ADDENDUM NO.2

**CHICAGO O'HARE INTERNATIONAL AIRPORT
TERMINAL 5 CONCOURSE M EXTENSION SITE/CIVIL PACKAGE
SPECIFICATION NO. 766477**

DESIGNED:	DRAWN:	CHECKED:
KRP	KRP	PD
PROJECT NO.: H2028.17-00		
DATE: 8/21/2018		
SHEET NO.		REVISION
GI-102		1

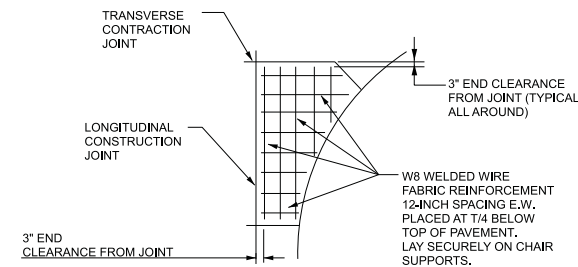
DRAWING SHEETS	
GI-102	LS-100 is not used and has been removed from the index.
GC-202	Modified the descriptions and durations for Work Areas D and F.
CP-102	Extended single face barrier wall 100 LF. Modified the existing transition between the new apron pavement and existing Spine Road pavement.
CP-202	Extended single face barrier wall 100 LF. Modified the existing transition between the new apron pavement and existing Spine Road pavement.
CP-212	Modified Doweled Construction Joint Details for Types C, E, and G to reflect the correct paving thicknesses.
CP-213	Removed the PCC Pavement Restoration detail.
CG-202	Modified the grading associated with the transition between new apron pavement and existing Spine Road pavement to reflect the revised transition and single face barrier wall extension.
CS-402	Modified the Type B fence limits to reflect the single face barrier wall extension.
S-101	Modified the Elevation View, Plan View, and Elevation Table to reflect the single face barrier wall extension.

Response:	<i>Refer to Specification Section 01524 Construction Waste Management.</i>
Question 54:	Sheet GI-102 indicates existence of drawing number LS-100 Life Safety Plan -1, this drawing is not found on the plan disc, will it be provided for the bid?

Response:	<i>LS-100 is not used. Drawing Sheet GI-102 has been modified to remove this sheet.</i>
Question 55:	Roof specs call for TPO roof, but plans call for PVC roof. Please clarify.

CP-213

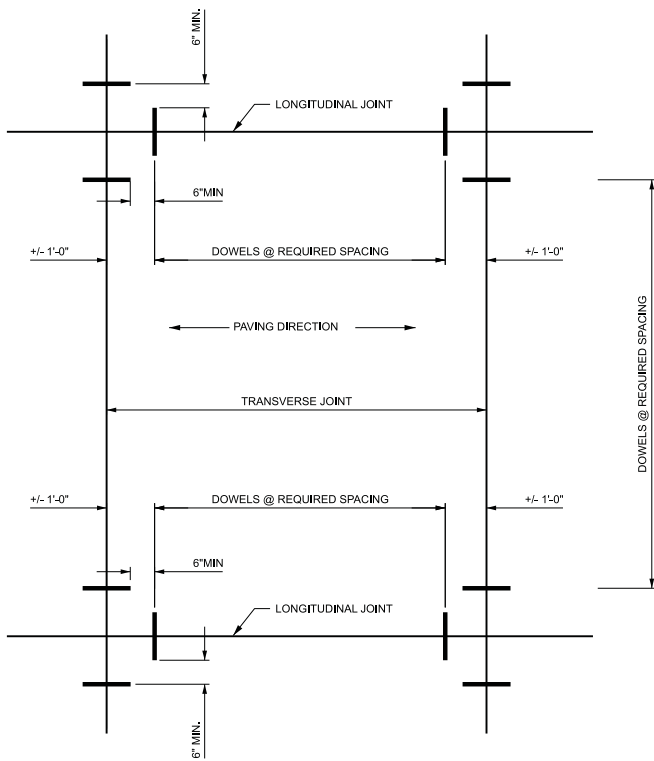
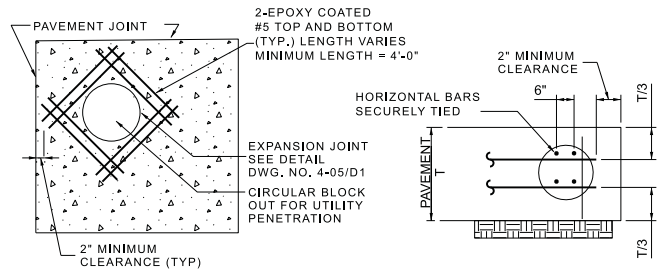
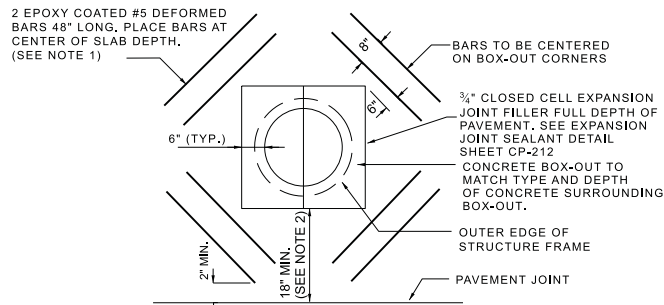
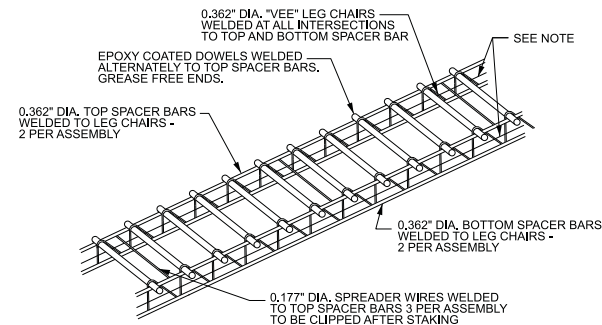
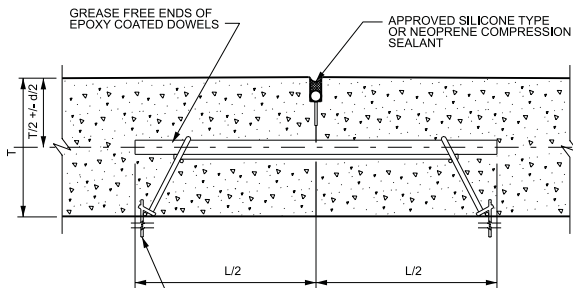
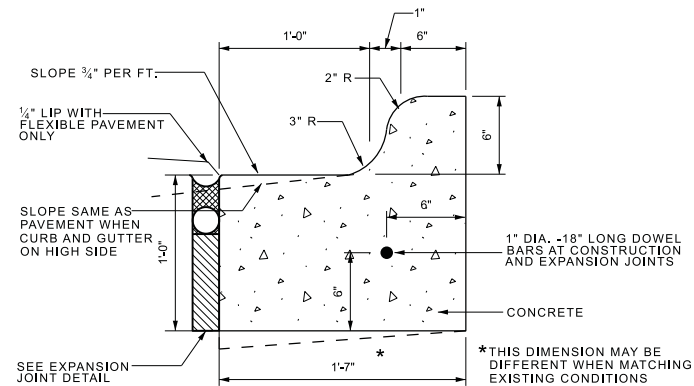
Response:	<i>See response to Question 9 above.</i>
Question 39:	Sheet CP-213 Shows a detail in the upper left hand corner called "Typical Fillet and Reinforcement Details". This is the typical detail we see at O'Hare for reinforced PCCP panels. In the lower right hand corner on CP-213, we see two details titled "PCC Pavement Reinforcement" and "PCC Pavement Restoration". Which detail shall we use in 19.5" panels labeled "R" on the joint plan? Where do the two details in the lower right hand corner apply?

Response:	<i>Minor changes to Drawing Sheet CP-213 have been made. Use the "Typical Fillet and Reinforcement Details" along with the "PCC Pavement Reinforcement" detail. The "PCC Pavement Restoration" detail is currently not used in this contract.</i>

10/4/2018 5:50:50 PM
Projects\602766\00_ORDTS\600_CADD\05_Official\02_Sheets\CP-H2028_17-00-ED-102-ELEC DEMO.dgn

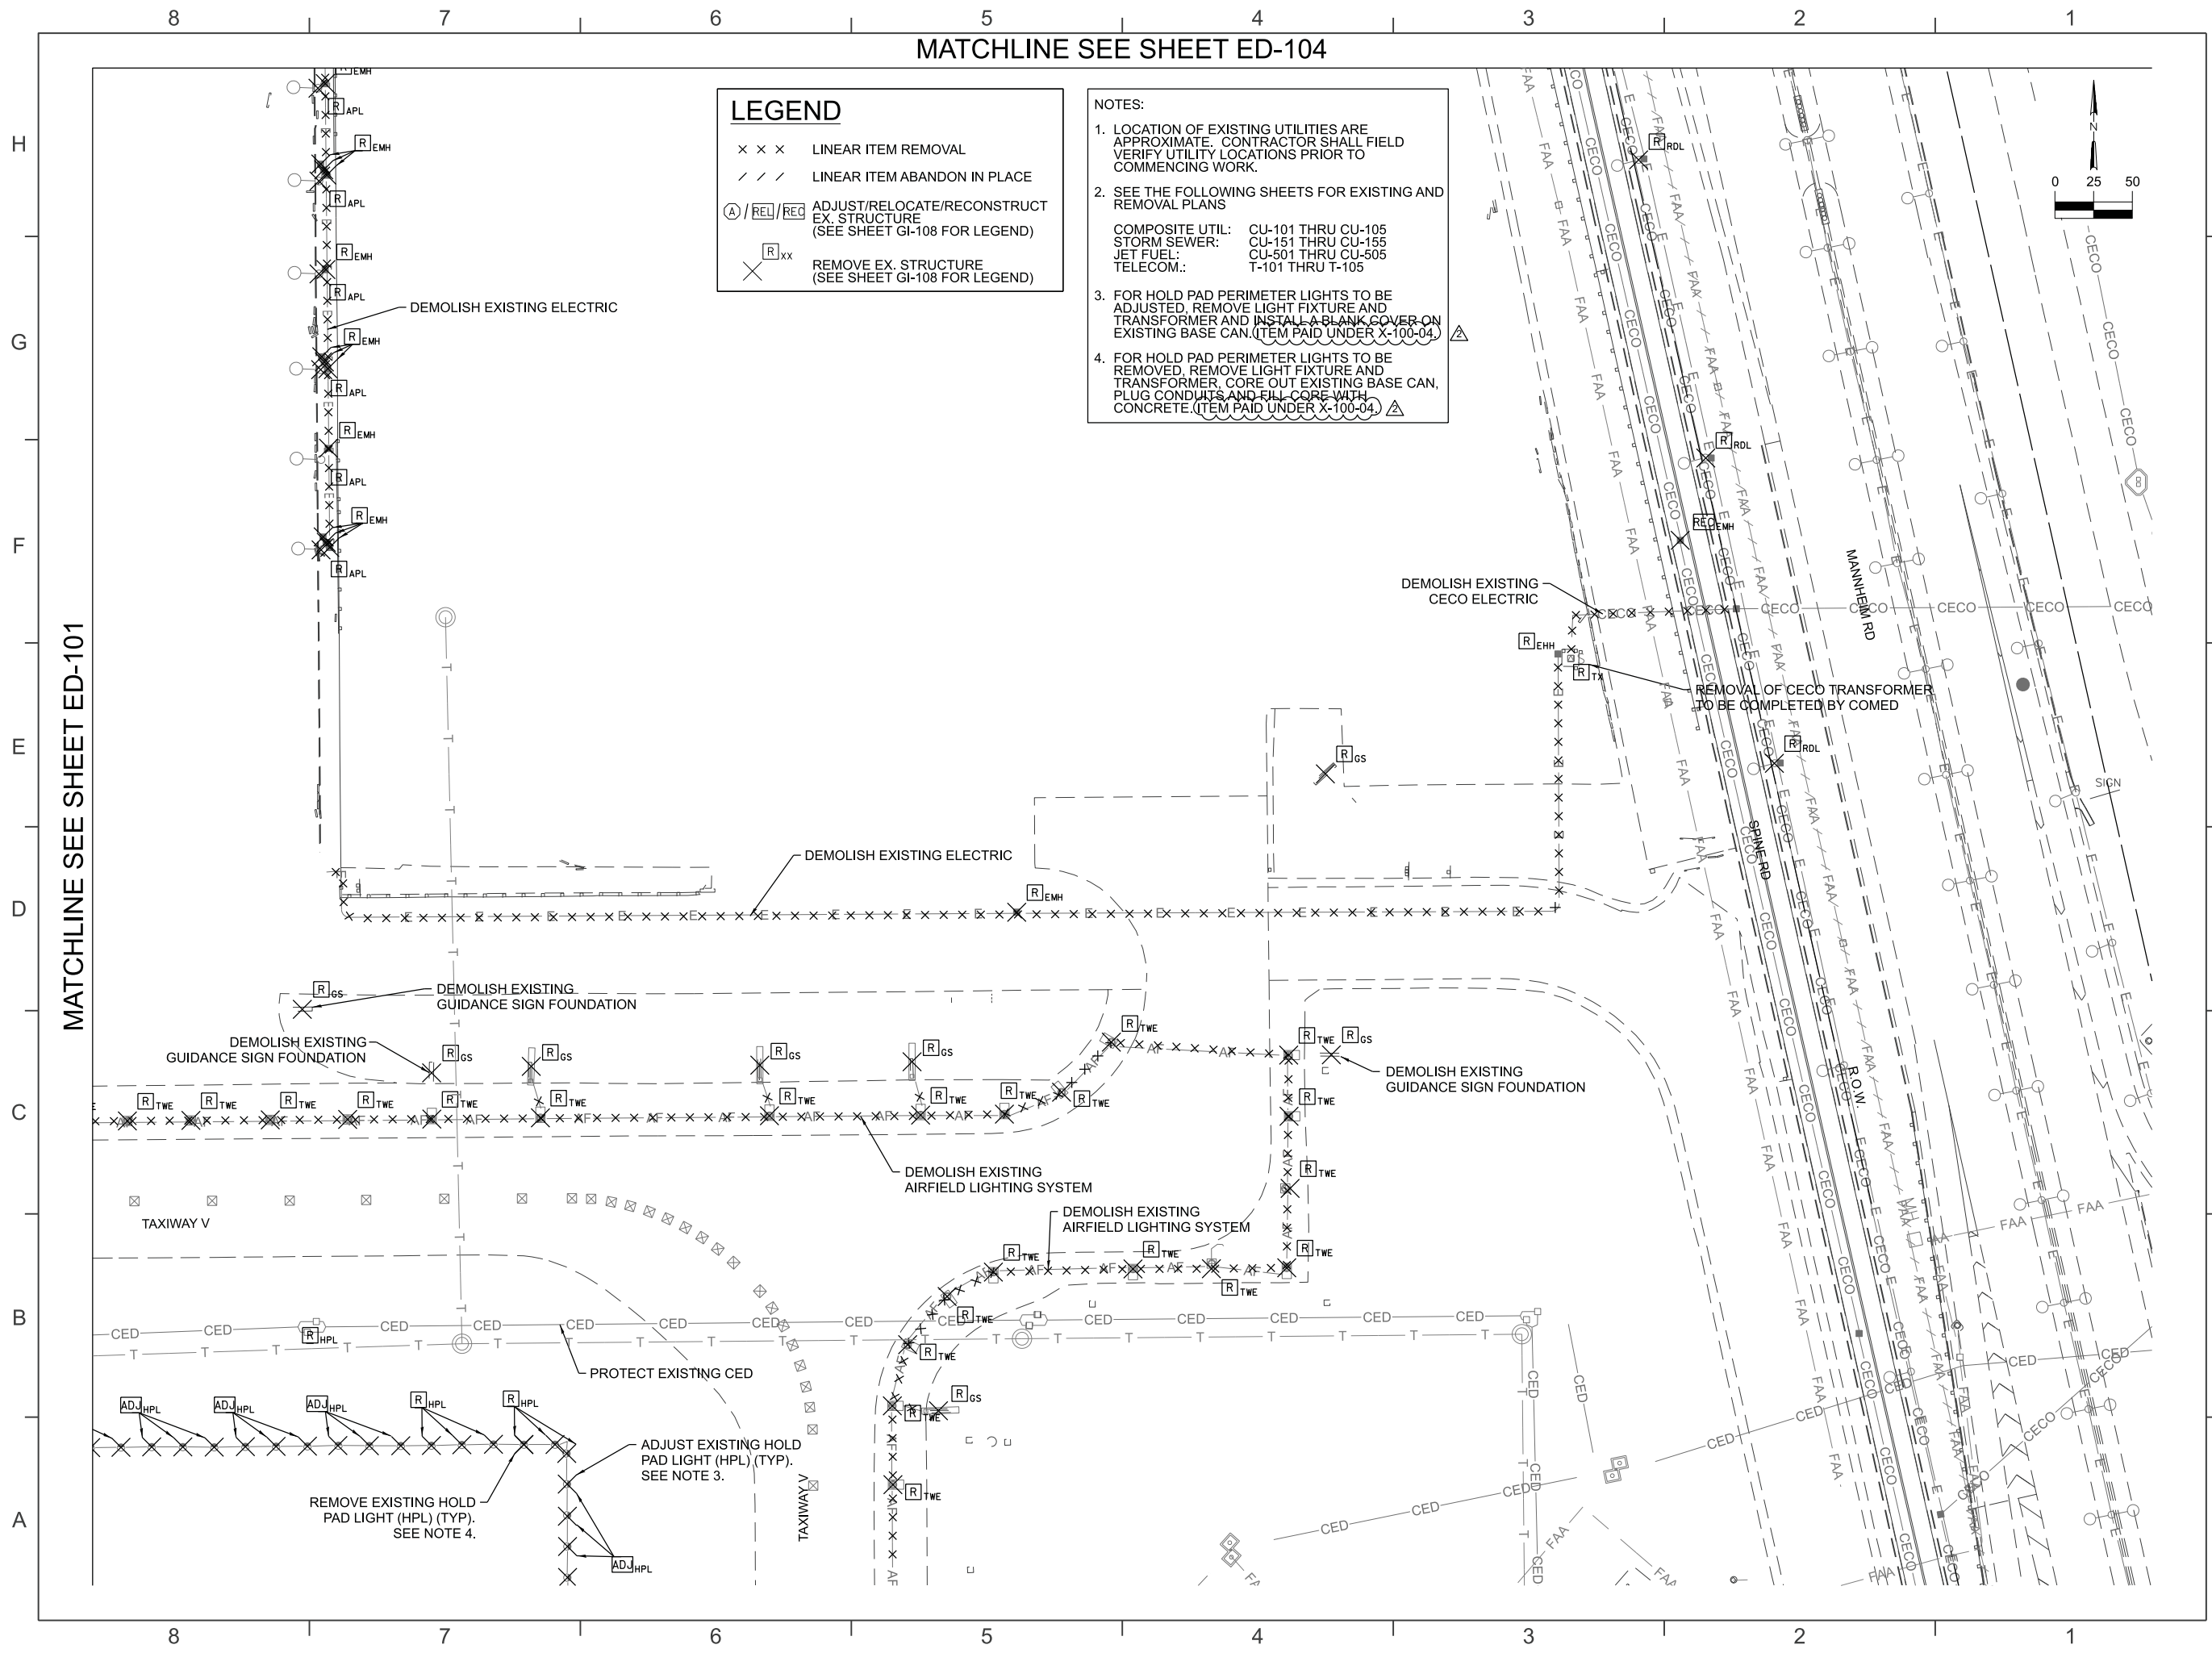
ED-102	Modified Notes 3 and 4 to clarify pay item associated with hold pad perimeter light removals and adjustments.
ED-103	Removed 1 light pole adjustment along Balmoral Ave.
ED-104	Removed 2 light pole adjustments along Balmoral Ave. Modified the reconstruction of 2 electrical handholes along Balmoral Ave. to removal of the 2 handholes.
ED-105	Removed 3 light pole adjustments along Balmoral Ave. and modified the reconstruction of 2 electrical handholes along Balmoral Ave. to removal of the 2 handholes.
ED-106	Modified Notes 3 and 4 to clarify pay item associated with hold pad perimeter light removals and adjustments.
ED-107	Modified Notes 3 and 4 to clarify pay item associated with hold pad perimeter light removals and adjustments.
ES-201	Added additional conduit callouts and modified conduit schedule to clarify installation requirements under new pavement and existing pavements. Modified note for interior conduit installation to clarify that fueling contractor is responsible.

Question 20:	Sheet ED-106, Note 3 – Please clarify how the adjustment of the hold pad perimeter lights is paid.
Response:	<i>Work is to be paid as part of the electrical demo. Notes have been added to Drawing Sheets ED-101, ED-102, ED-106, and ED-107. Specification X-100 has been updated with the description of work.</i>

SHEET NO.	REVISION
ES-201	1

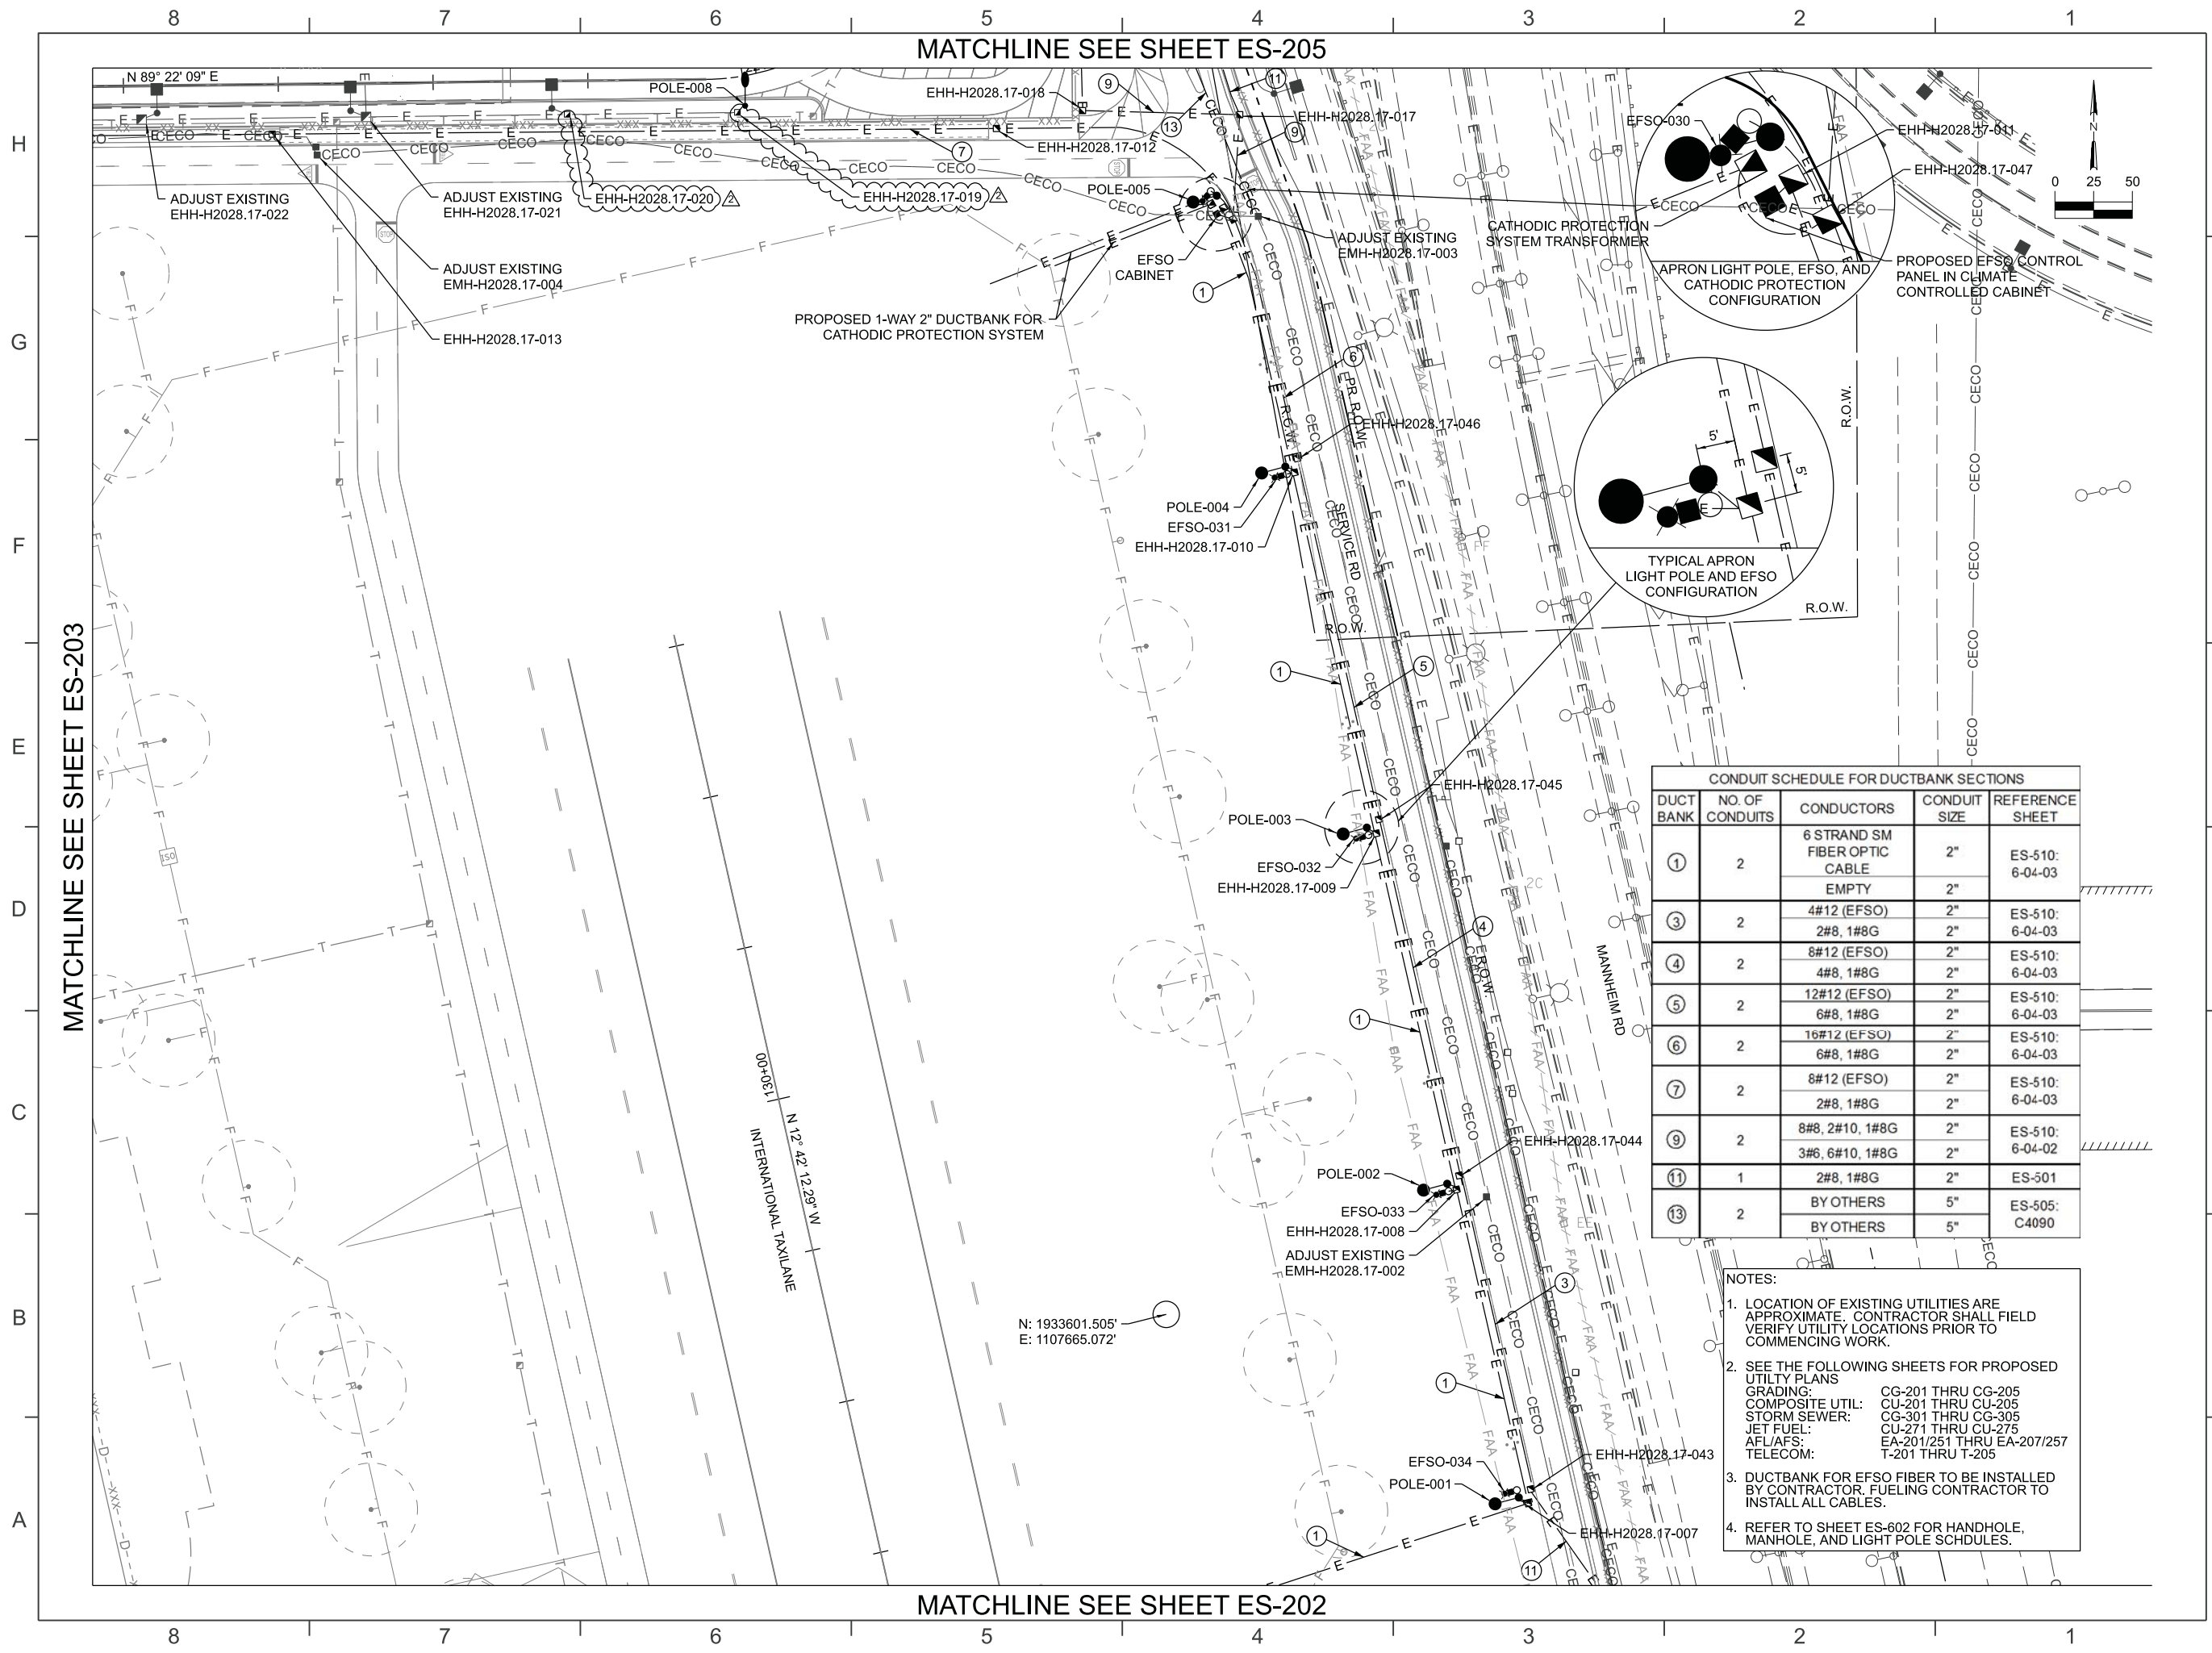
Question 25:	Sheet ES-201 shows EFSO ductbank and handholes that are in the footprint of the building package work. Is the contractor to sawcut through existing pavement to install this work? What are the restoration requirements?

Response:	<i>Drawing Sheet ES-201 has been updated with clarification notes for separation of the work. A new detail has been referenced for the sawcut through the pavement.</i>
